DRAWING TITLE		
BASEMENT B2 PLAN		
SCALE	DRAWN BY	PLOT DATE
1:100 @ A1	SG / AW	19/01/2022
PROJECT NO.	DRAWING NO.	REVISION
1511	DA-02	H

PROJECT
MIXED-USE DEVELOPMENT
321 - 331 CONDOMINE STREET
MANLY VALE NSW 2093
LOTS 20, 21, 22 & 25 on DP 11320
LOT 123 on DP 737259

Plans approved by the Land and Environment Court of NSW
PROCEEDINGS NO: 2021/266483
DATED: 11 February 2022

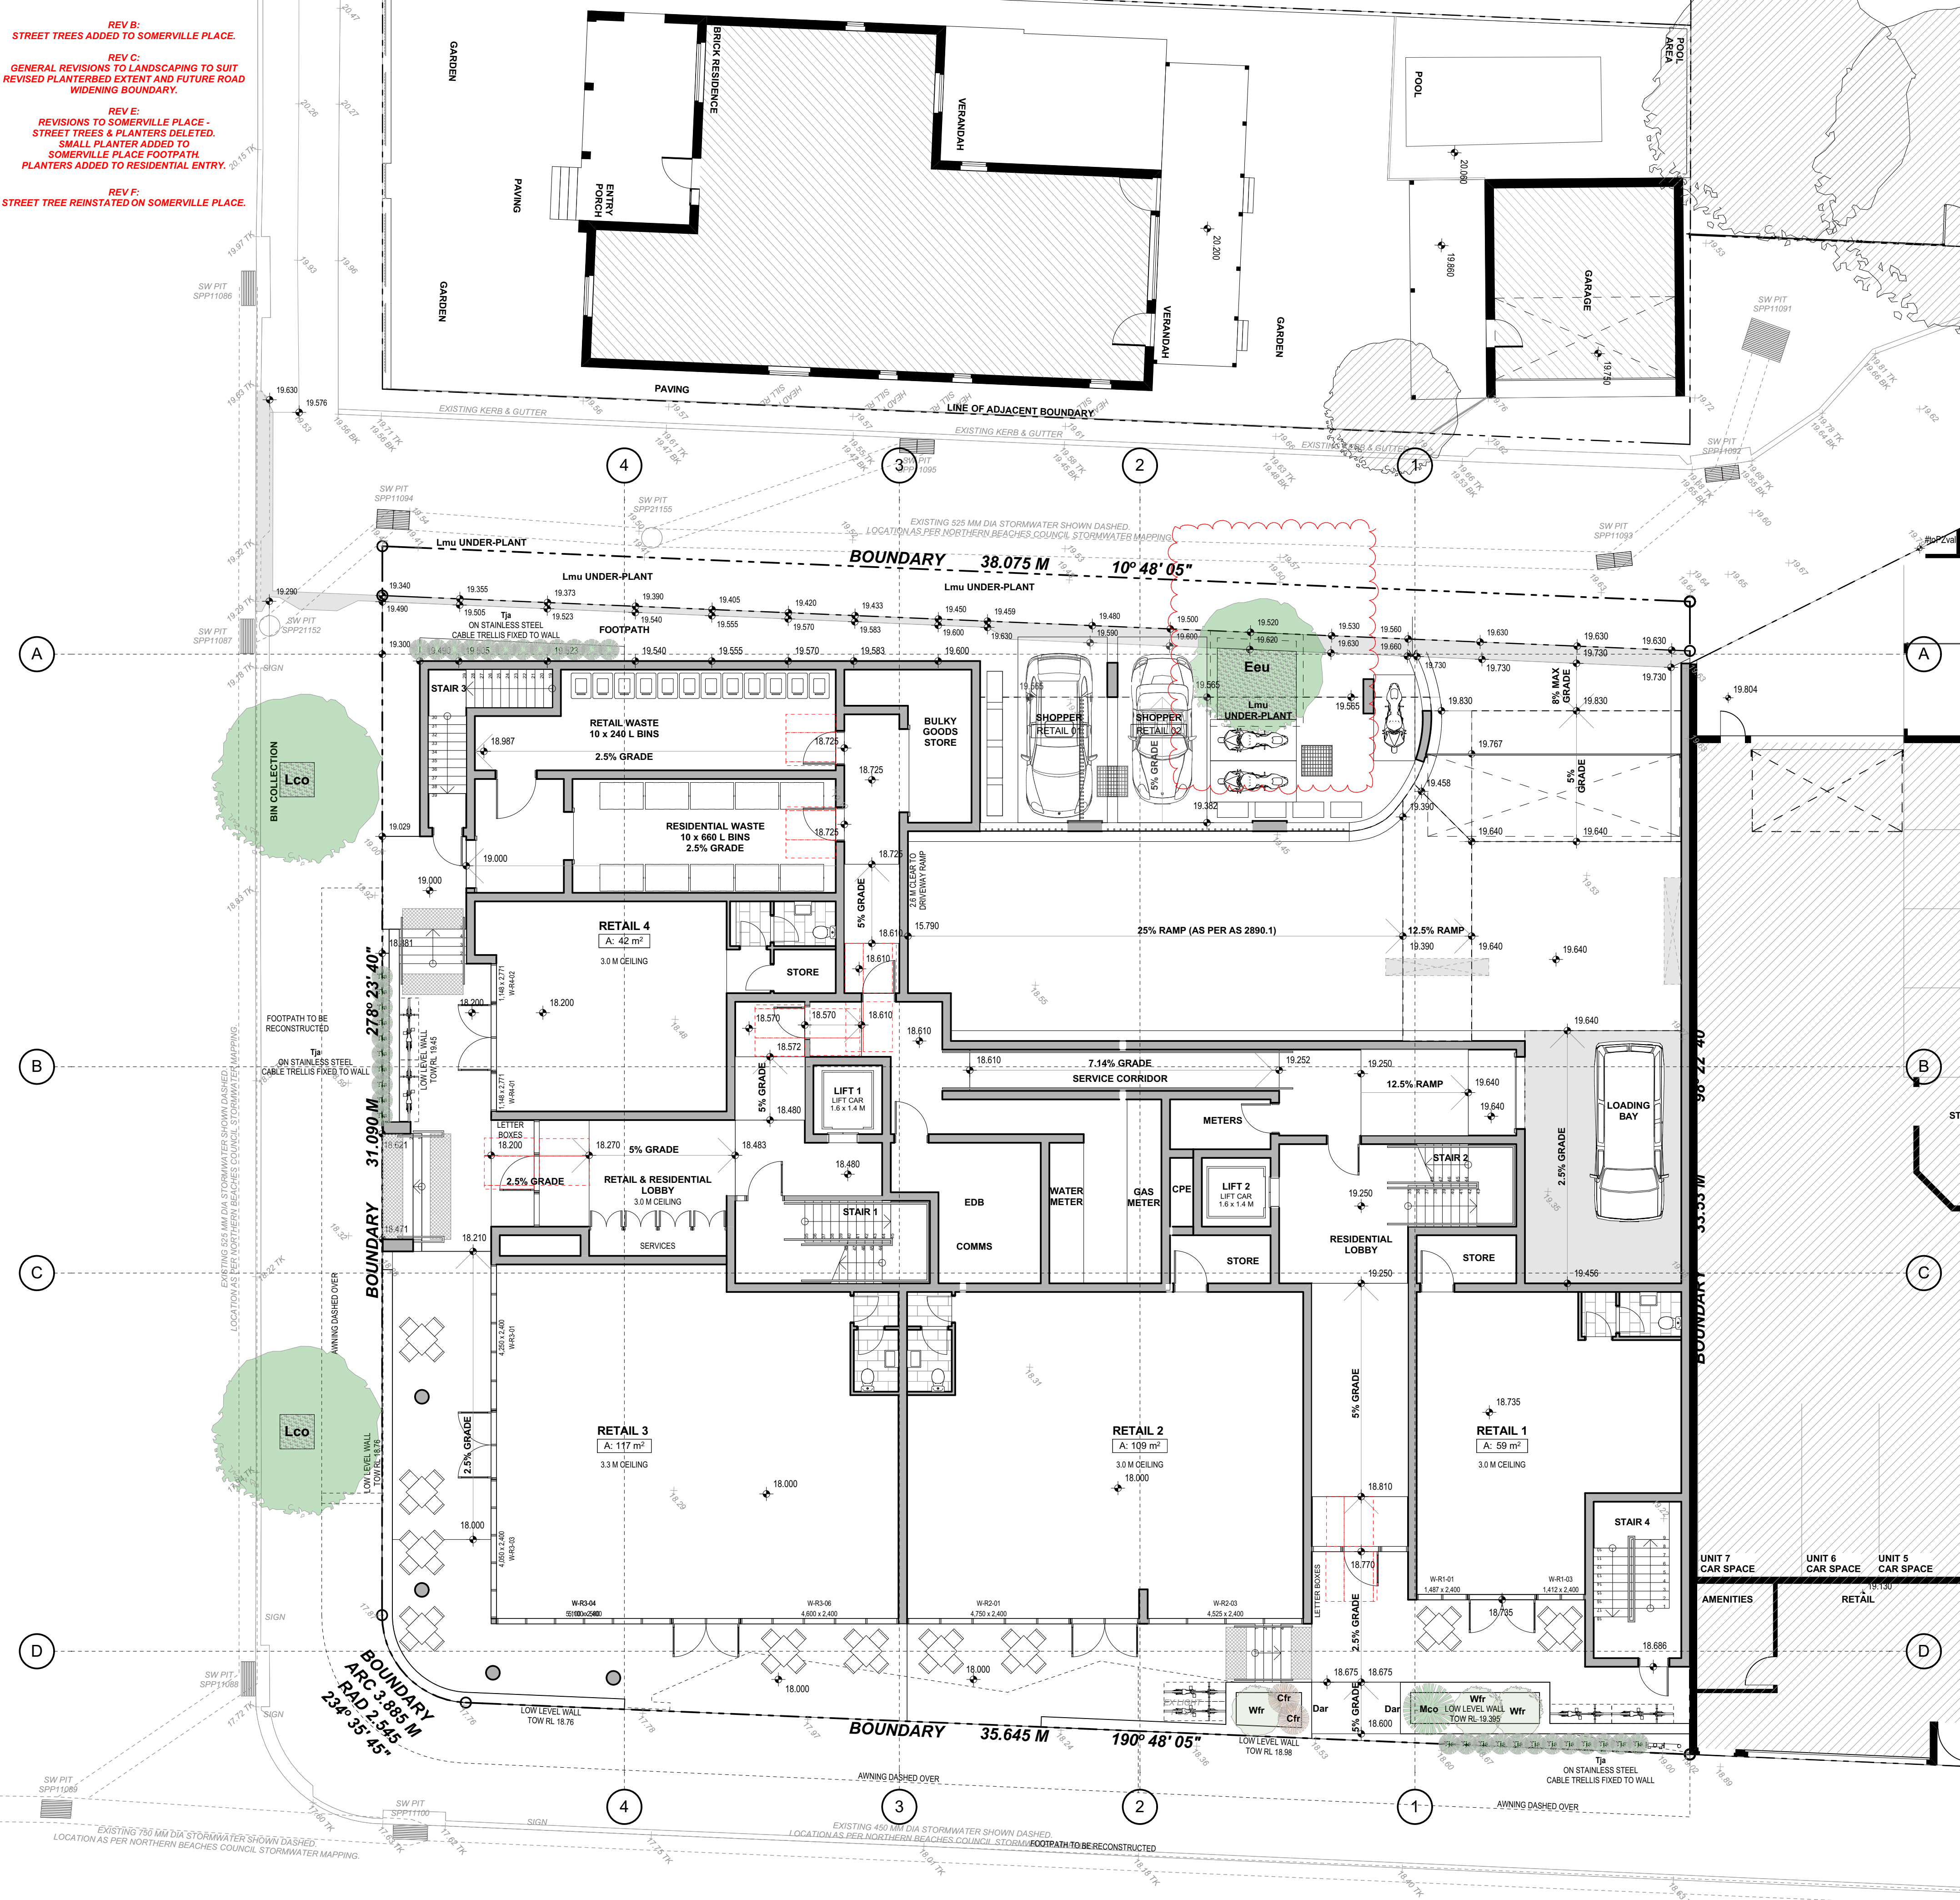
REV B:
STREET TREES ADDED TO SOMERVILLE PLACE.

REV C:
GENERAL REVISIONS TO LANDSCAPING TO SUIT
REVISED PLANTERBED EXTENT AND FUTURE ROAD
WIDENING BOUNDARY.

REV E:
REVISIONS TO SOMERVILLE PLACE -
STREET TREES & PLANTERS DELETED.
SMALL PLANTER ADDED TO
SOMERVILLE PLACE FOOTPATH.
PLANTERS ADDED TO RESIDENTIAL ENTRY.

REV F:
STREET TREE REINSTATED ON SOMERVILLE PLACE.

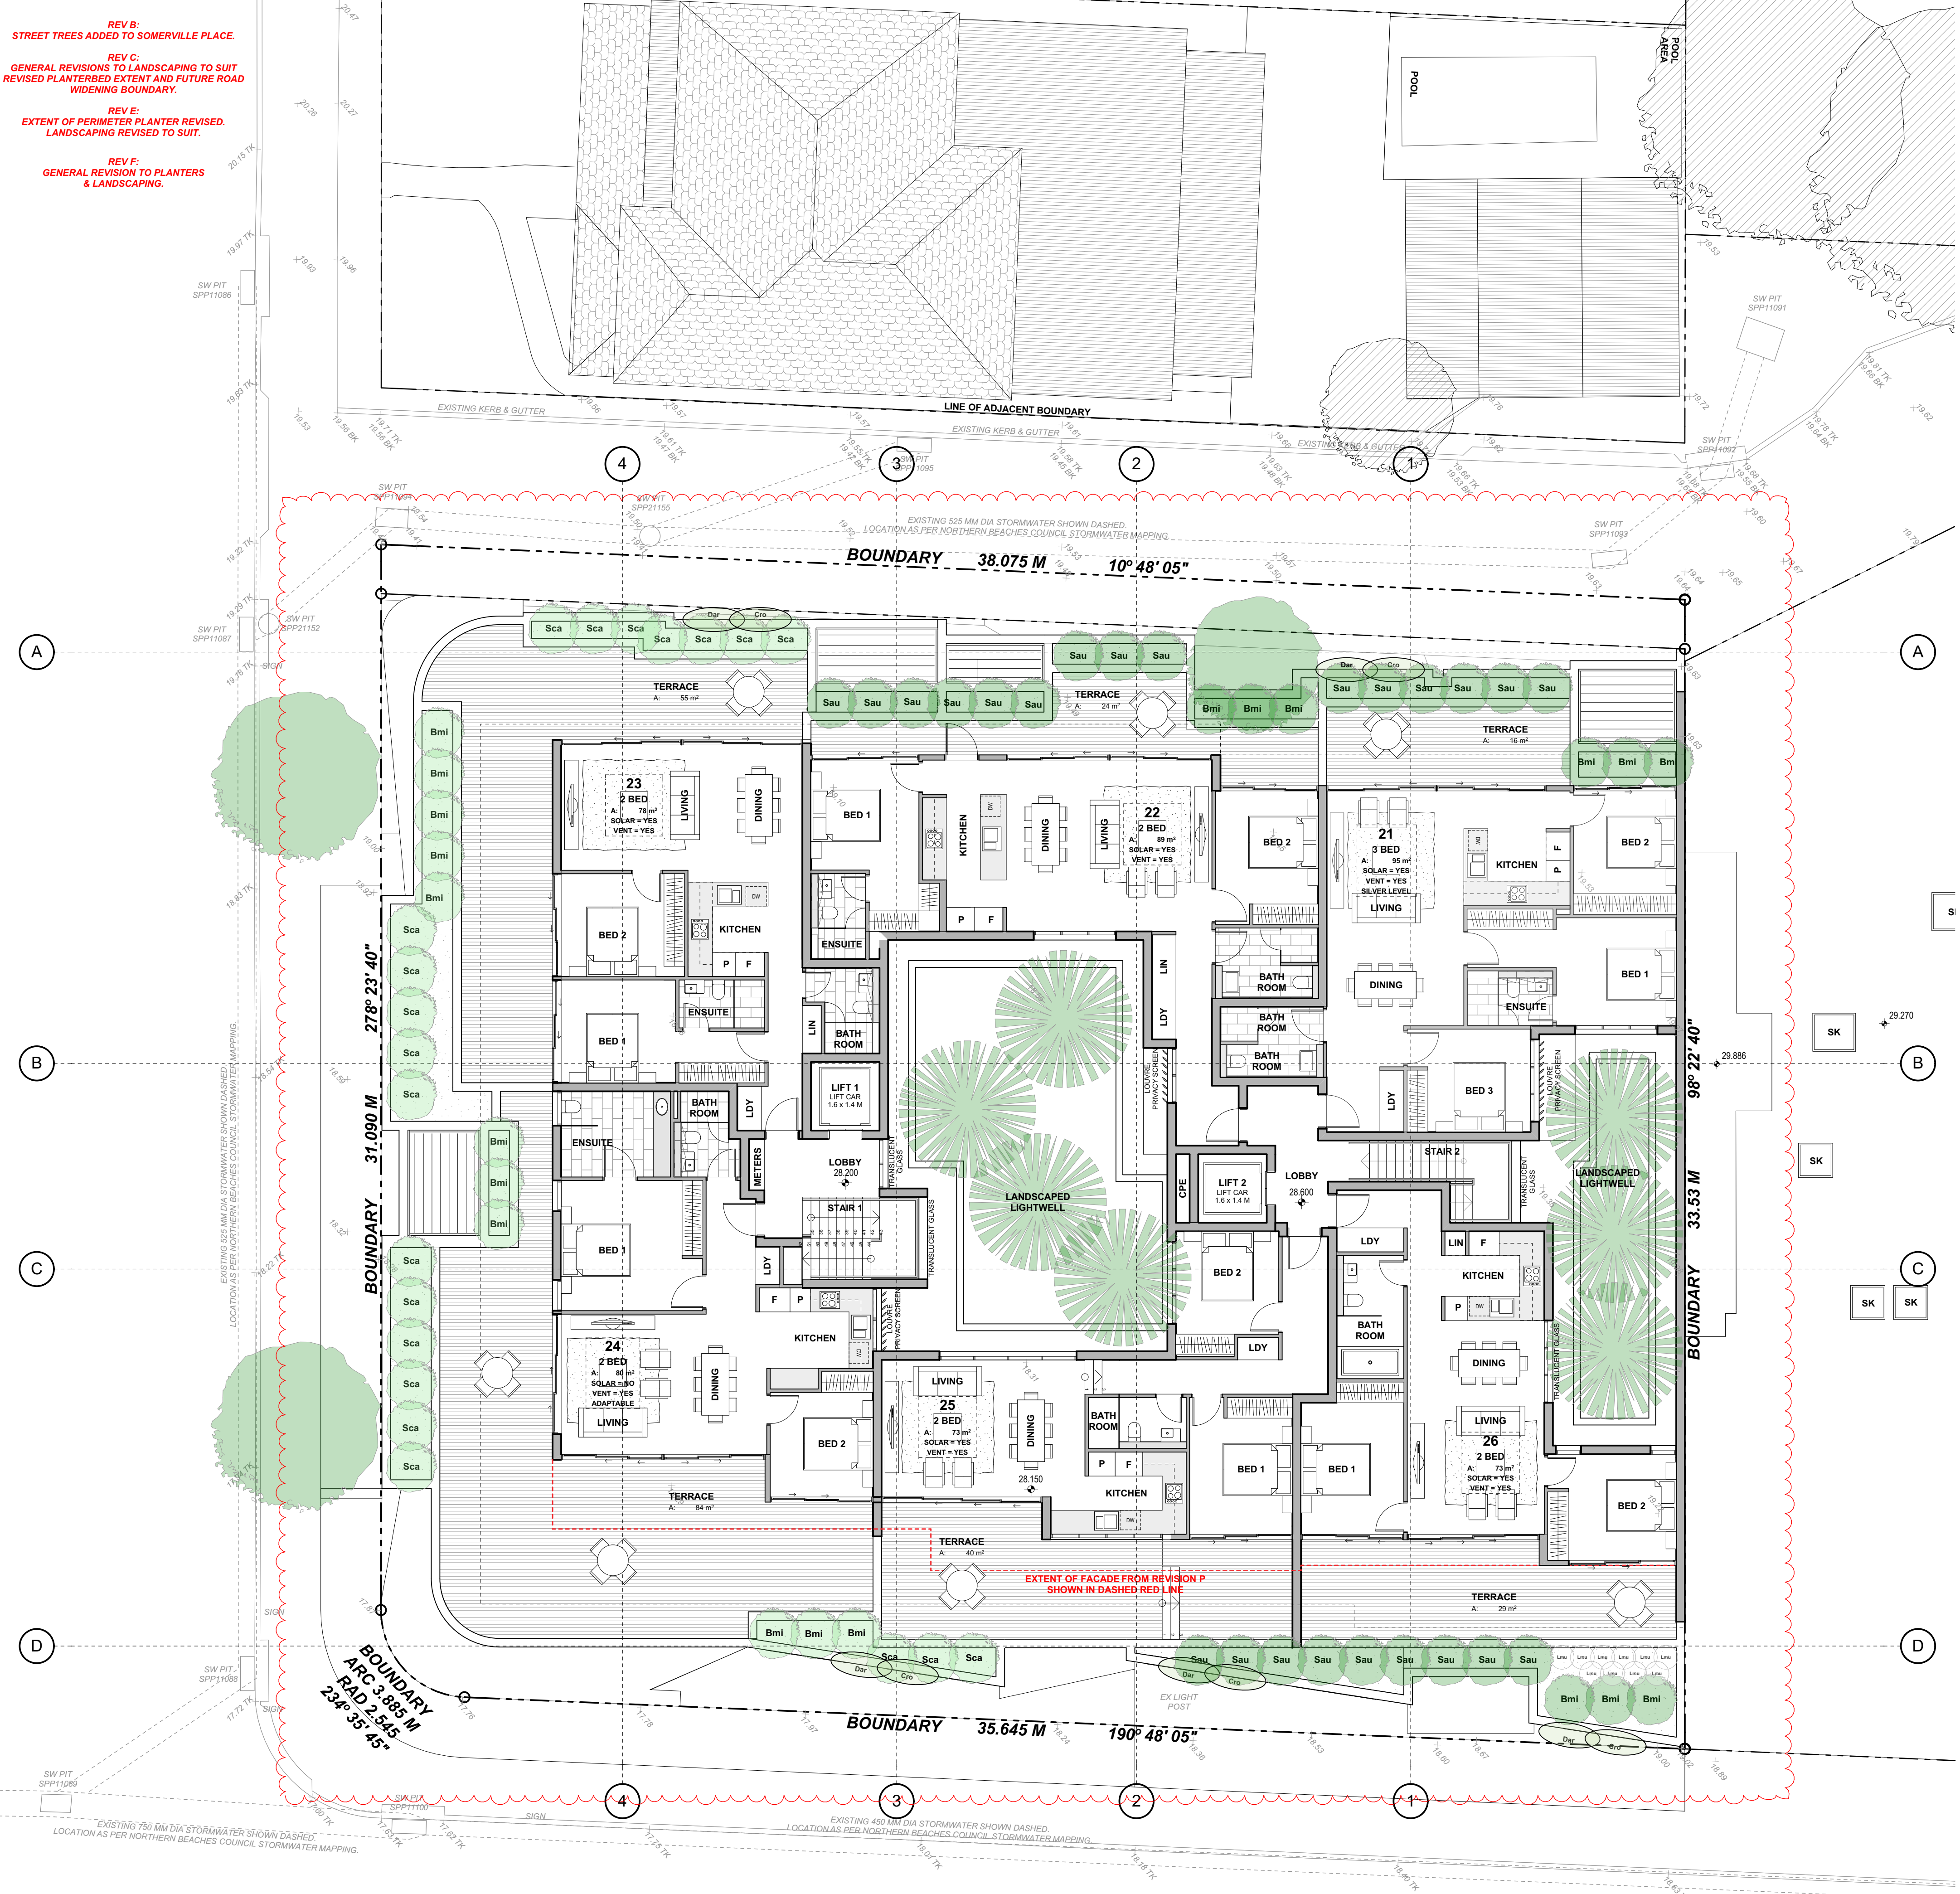
REV B:
STREET TREES ADDED TO SOMERVILLE PLACE.

REV C:
GENERAL REVISIONS TO LANDSCAPING TO SUIT
REVISED PLANTERBED EXTENT AND FUTURE ROAD
WIDENING BOUNDARY.

REV E:
EXTENT OF PERIMETER PLANTER REVISED.
LANDSCAPING REVISED TO SUIT.

REV F:
GENERAL REVISION TO PLANTERS
& LANDSCAPING.
